New Albany Architectural Review Board
Monday, June 8, 2026 Meeting Minutes - Approved

**Architectural Review Board Staff Report
June 8, 2026 Meeting**

**6600 NEW ALBANY-CONDIT ROAD OFFICE
FINAL DEVELOPMENT PLAN**

Image: Proposed site layout, showing the buildings, pavement and parking, and general landscaping.

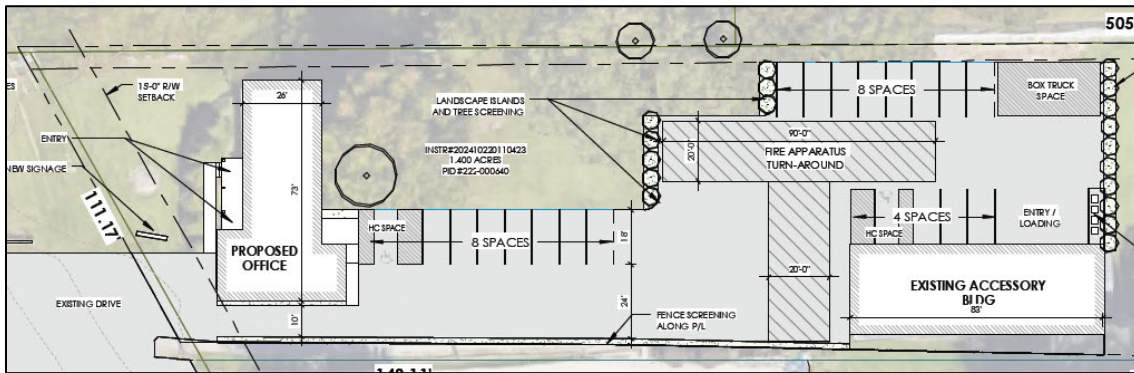
4. The distance of the pavement from the southern lot line is unclear. Staff recommends a condition of approval that the parking lot pavement be at least five feet away from the southern property line (condition #1).
5. **Lot coverage:** The zoning text permits a maximum lot coverage of 80 percent, which includes both buildings and pavement. The applicant is proposing a lot coverage of approximately 42 percent. The requirement is being met.

The City Engineer has reviewed the final development plan and provided the following comments. Staff recommends a condition of approval that these comments be addressed by the applicant, subject to staff approval (condition #5).

1. Provide evidence that all existing private well and septic systems have been abandoned in accordance with all applicable environmental regulations.
2. Show how water and sanitary service will be provided.
3. Show ODOT Limited Access right-of-way on the plans and advise if an ODOT permit is required to support the project.
4. Provide a fire truck turning radius analysis and obtain Fire Department approval.

5. Show major flood routing on the grading plan and design the driveway so that most of the runoff is directed away from the public road.
6. Show stop signs and stop bars at the driveway curb cut and add site distance triangles. Remove impediments to motorist view.
7. Work with staff to determine what improvements are required in the public right-of-way to support the project.
8. Add a table showing parking stalls required and provided and ADA stalls required and provided.
9. Provide more information about anticipated traffic volumes.
10. Provide a photometrics plan.

Image: Axonometric sketch from the City Architect depicting the proposed garage relative to the main entry mass.

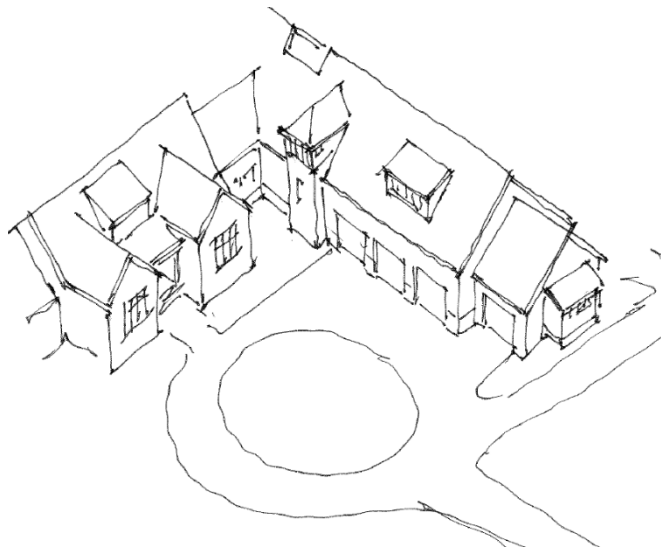
Board Member Davie stated that this project would benefit from three-dimensional imagery; the two dimensional seems overwhelming. He noted that he counted seven roofs, which is too many roofs.

Chair Hinson remarked that he does not have a problem with the overall massing, observing that the property is quasi remote, but the design should be more consistent. The garage height needs to not exceed the roofline of the house as proposed in waiver b; there are many opportunities to simplify.

- The applicant proposes a new home with a large garage mass extending approximately 55 feet from the main portion of the home toward the public right-of-way. The garage mass includes four garage doors that face the eastern side yard and are not front facing, though they are in front of the main portion of the house. The garage mass appears to be approximately 30 feet in height and is one of only a few portions of the house with a second-story dwelling area.
- DGR Section 1(I)(E) states that parking areas and garages should be placed in locations to minimize their visual impact through a combination of garage location and landscaping or other screening methods. It further states that garage doors should not be on primary façades

- The waiver does not meet the intent of the standard or the goals of other city regulations. The garage doors technically do not face the primary road as recommended by the DGRs and Strategic Plan; however, the garage form and location do not minimize the visual impact of the garage. If the garage mass were to be integrated into the rest of the home or scaled down rather than essentially standing alone from the rest of the building, it may better fit with the goals of the DGRs. At a minimum, the height of the garage mass should be decreased.

Building B - Proposed

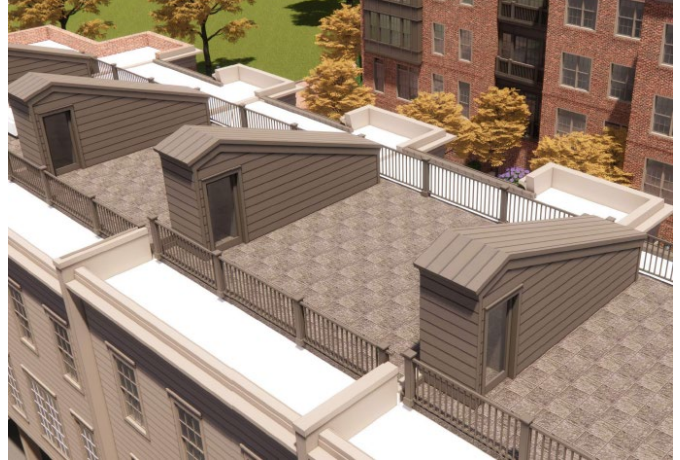
Board Member Davie remarked that with the skylight version it makes sense to repeat it, but with a pop up on the left it might make sense to mirror rather than having them all on the same side. As proposed they look like fingers. He further remarked that this feels like the solution to a problem and lacks cohesiveness, it does not feel like an impressive solution.

The applicant is requesting modifications to the townhome building (Building B, as shown on the site plan below), including the removal of skylights, elimination of half-height privacy walls between units, and the incorporation of rooftop garden access structures.

The City Architect reviewed the proposed revisions, including the removal of the skylights and addition of the rooftop garden access structure, and expressed no concerns with the changes. The modifications will have minimal impact on street views while significantly improving functionality and access for future occupants.

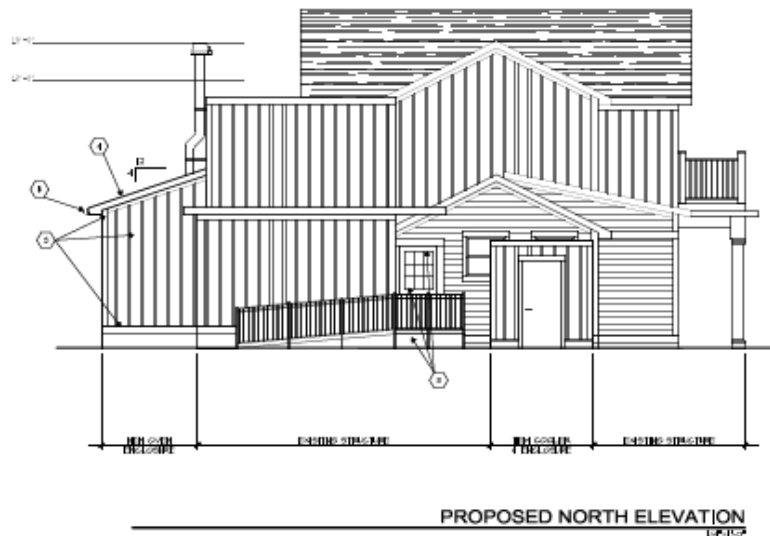
- The cooler enclosure is proposed to be detached and located next to the existing ramp on the north side of the building, and will have the same building materials as the existing structure on site.

- It appears that all of the proposed exterior building modifications appropriately relate to the original ARB approval through the use of the same Hardi board siding material, roof, trim, and details. While the applicant proposes to replace the double French doors on the east elevation, there are still two building entrances along this elevation.

- The applicant has not submitted sign plans as part of this submittal. Staff recommends a condition of approval that signage shall be subject to review and approval by the Architectural Review Board once details have been finalized (condition #1).

- A detailed landscape plan was not submitted as part of this application. To ensure consistency with the landscaping from the previously approved COA (ARB-135-2021), staff recommends a condition of approval that a detailed landscape plan be provided as part of the building permit and be subject to staff approval (condition #2).
